RFI No. 002: SOLICITATION REQUEST FOR INFORMATION

Project: Port Townsend, WA Main Office Exterior Restorations

Project Number: B14633

Sandstone patching thickness

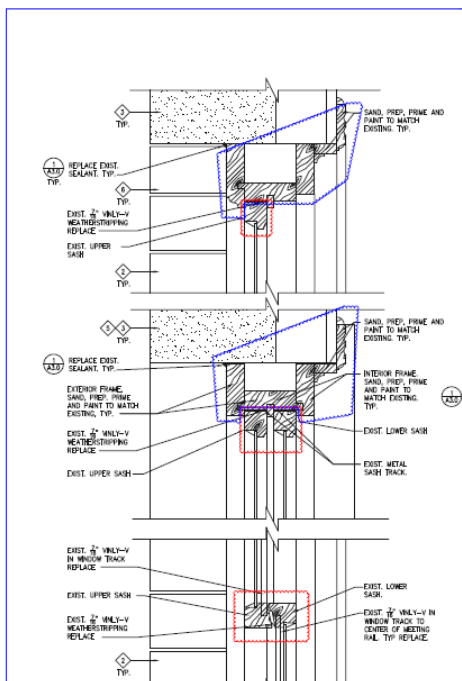
Q6: Where sandstone is delaminated, a patch with a thickness of ¼” or less is often a risky solution. The shallowness of the patch does not allow for much integrity. Is it acceptable to leave anything ¼” or less as is, and only repair where the patch is thicker than ¼”?

See section 044700 3.02 for the requirements.

Section from drawing A2.3

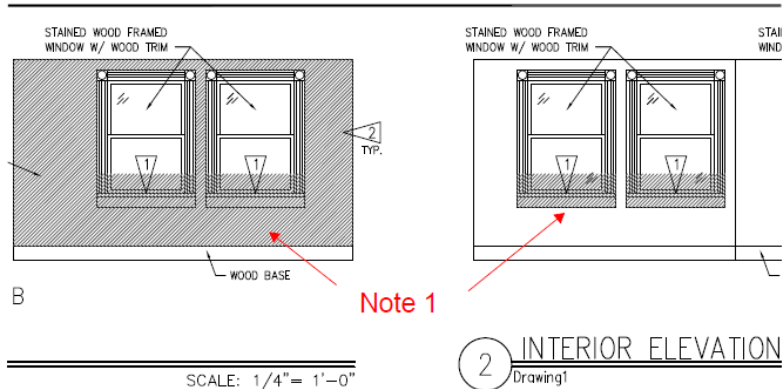
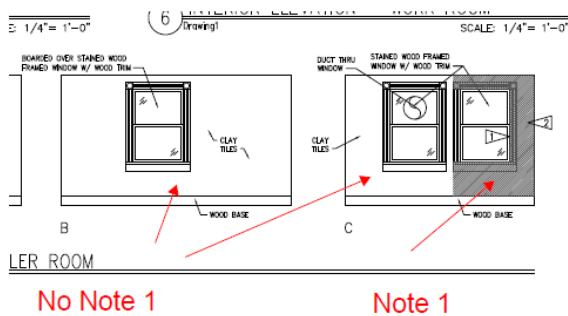
Q8: Please verify that for documentation/pricing purposes, we are to assume all window interior trim to be treated where note (1) occurs and NO interior trim to be treat where note (1) is absent.

Provide the bid according to the contract bid documents.
